670 N SNELLING

Address: 670 Snelling Ave N

SITE PLAN APPROVED
OFFICE OF DSI
CITY OF ST. PAUL
By Karen Zacho 5.29.18
File # _____ Date ~~2.13.18~~
Any alterations from this plan must be approved by the Zoning Administrator.

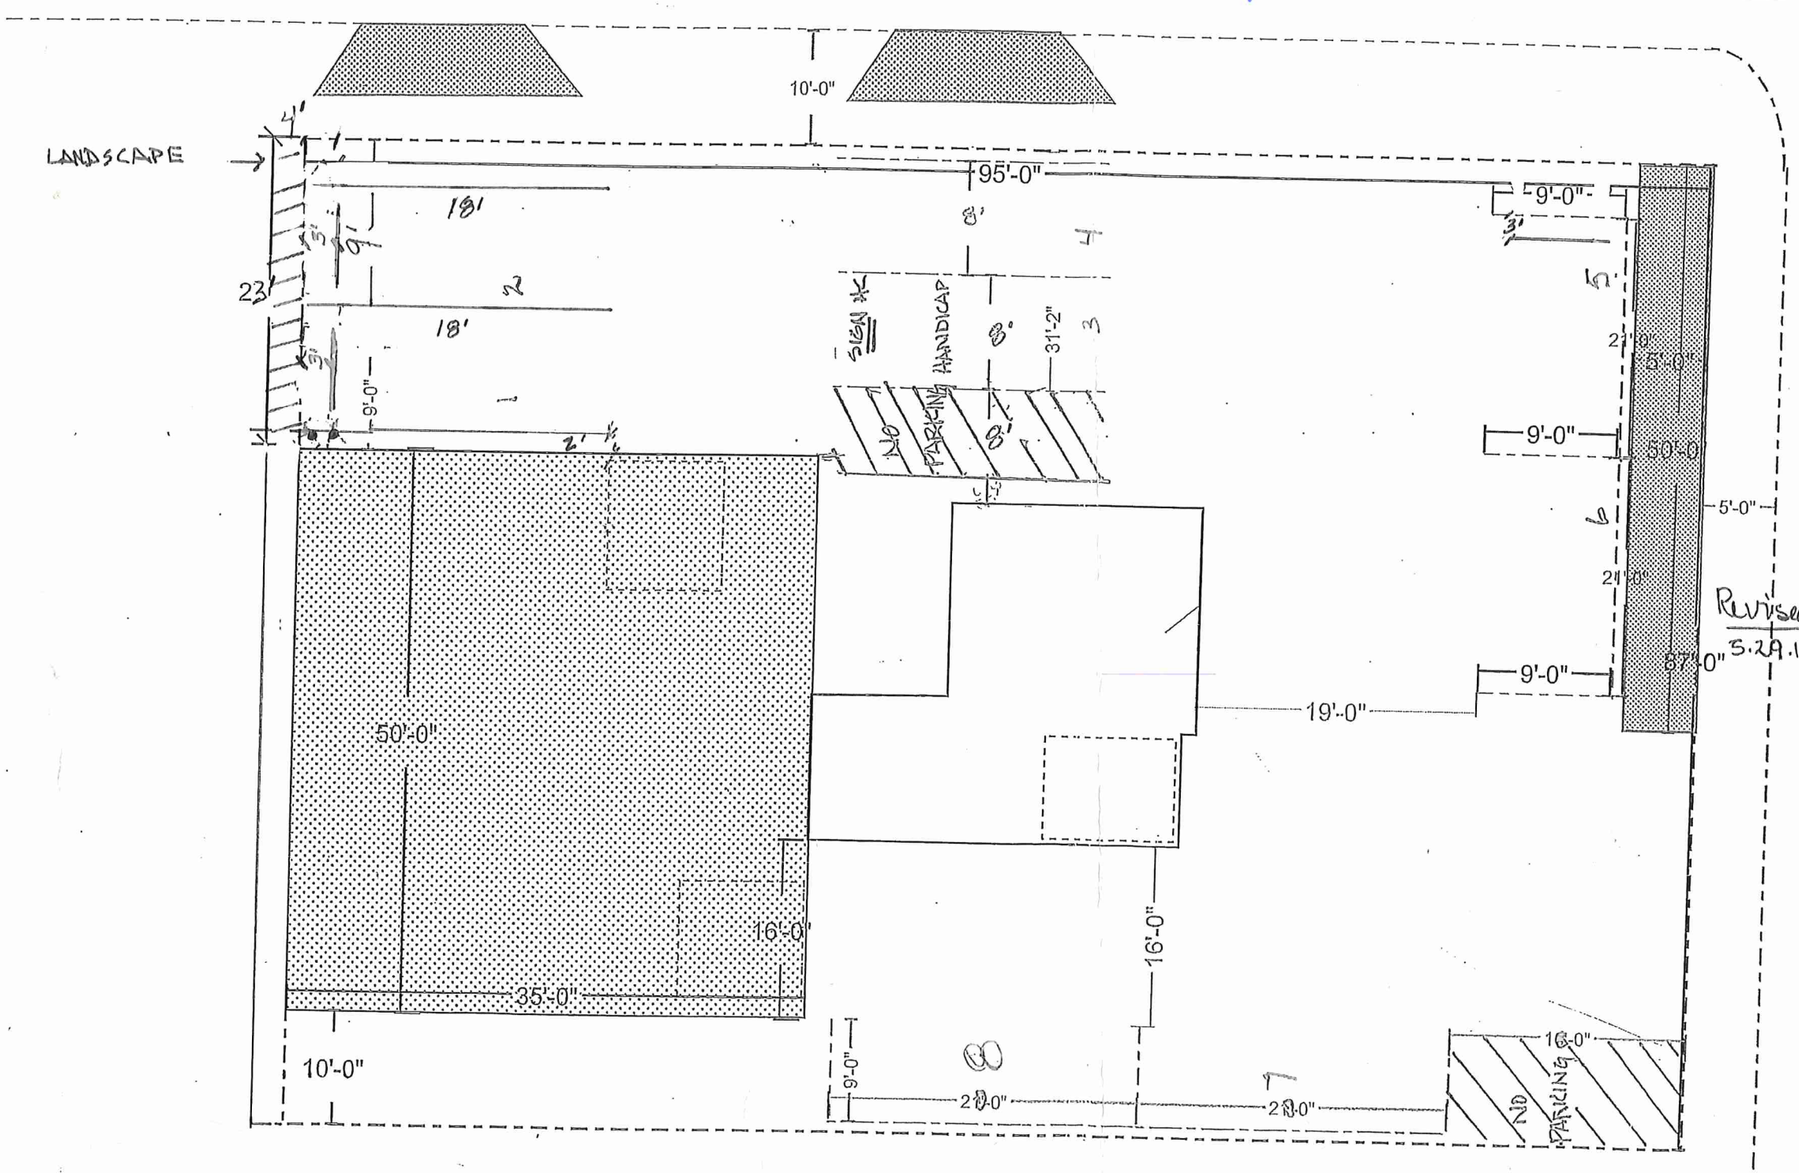
1) Trash shall be contained within the building until pickup day.

2) ADA parking sign shall be installed on parking space number three (3).

Revised 5.29.18 3) ~~Bollards~~ wheel stops shall be placed at parking spaces #1, 2 to maintain 4' setback off property line and #5 parking space to maintain vehicle within property line.

Rubber 6' x 4" x 6", anchored with 4 bolts per wheel stop. Spec sheet attached to file.
